OREGON STATE UNIVERSITY
TRIGA® REACTOR.
LICENSE NO. R-106
DOCKET NO. 50-243

RESPONSE TO RAI REGARDING HEU/LEU
CONVERSION

Subject: Oregon State University Response to RAI Regarding Conversion Amendment,
Oregon State University TRIGA Reactor dated April 22, 2008

Responses to NRC RAI Letter of April 22, 2008

Figure 4-32, Radial Power Profile and Radial Power Density Profile vs. Distance from Fuel Centerline for the Hot Rod in the OSU HEU BOL NORMAL Core.

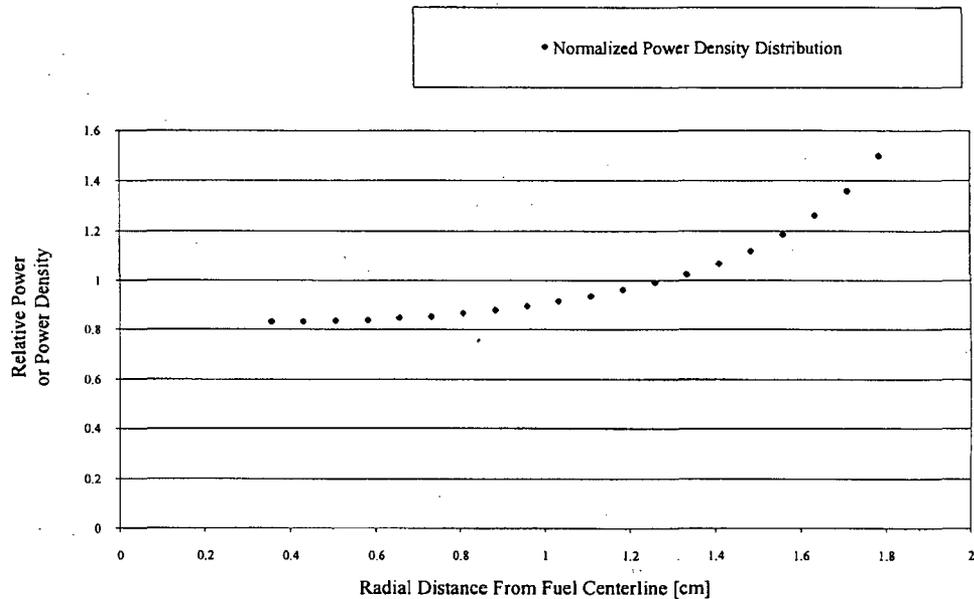
20. Section 4.7.2, Table 4-21. The analysis for the HEU core uses 84 fuel rods in the core although it appears from Figure 4-4 and Table 4-1 that there should be 85 rods present with control rods withdrawn. Please explain the difference.

Additional discussion of the radial peak factor calculations is found on page 57-58, and in figure 4-32. Figure 4-32 will be updated as shown, and the discussion of the radial peak factor calculations will be corrected.

Figure 24-1: Axial Bulk Coolant Temperature Distribution for 1, 2, & 8 Channel Model (HEU Beginning of Life Normal Core)

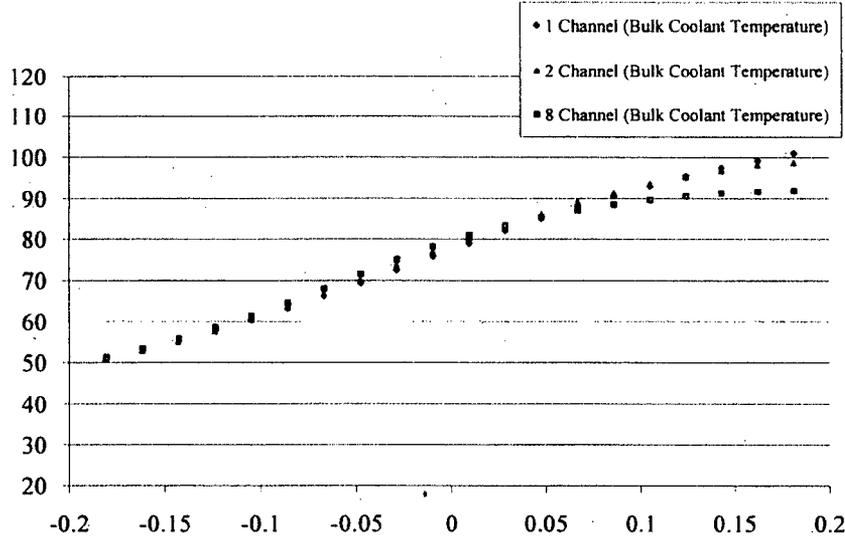
24. **Section 4.7.2. Please provide analytical justification for ignoring cross flow between neighboring flow channels.**

Figure 24-1 provides a quantitative comparison of the bulk coolant temperature distribution found in the one, two and eight channel models. This comparison provides evidence that with an increase in the number of subchannels there is an expected corresponding decrease in exit bulk coolant temperature.

Figure 4-23, Hexagonal Array Axial Average Unit Subchannel Dimension

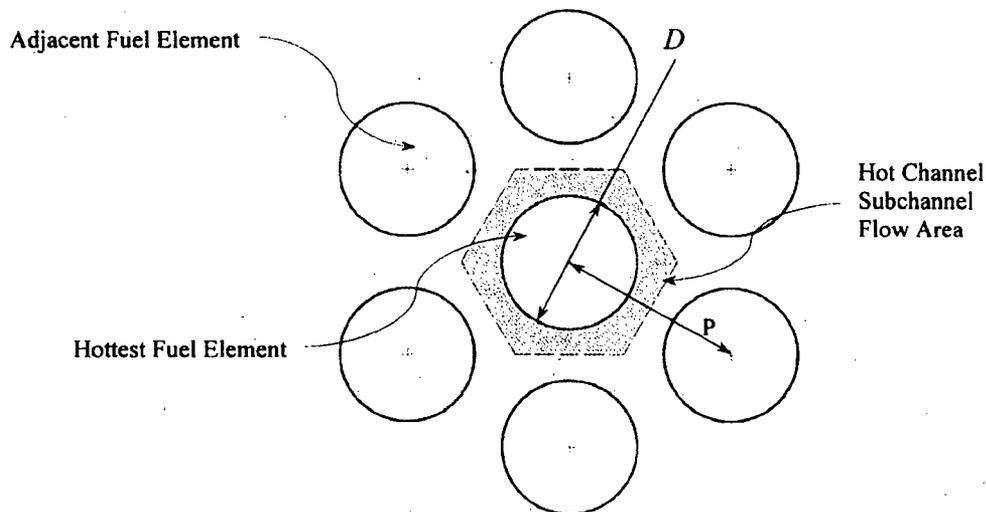
33. **Section 4.7.2, Table 4-18.** In accordance with the subchannel shown in Figure 4-23, a consistent definition for the heated diameter should be the heated perimeter divided by pi. That is the definition adopted by Bernath for his CHF correlation. In the conversion SAR, what was the heated diameter used in the Bernath correlation?

physical heated diameter. The correct value of 3.724E-02 meters was used in all calculations.

For clarity, we will replace Figure 4-23 with the following Figure:

Figure 4-80: LEU MOL ICIT, Fuel Temperature Distribution at Time of Prompt Max Fuel Temperature (\$2.00 Pulse)

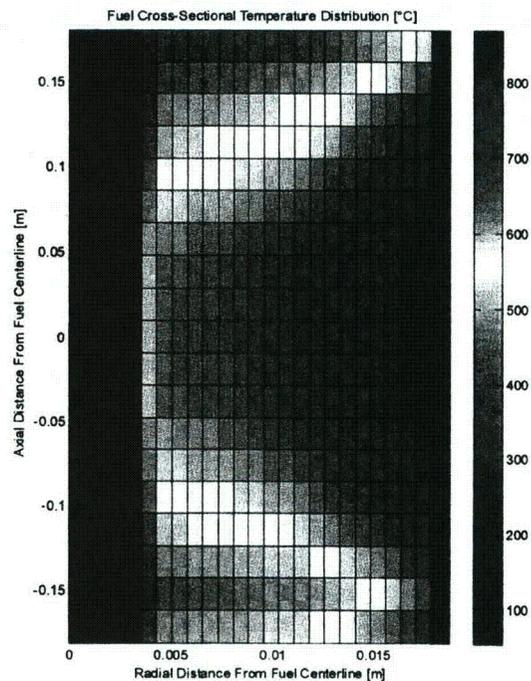
48. **Section 4.7.10, Figure 4-80.** Please note that the legend is incomplete in the pdf version.

Please refer to the figure below for the temperature contour during time of peak fuel temperature for the LEU MOL ICIT core, including a complete legend.
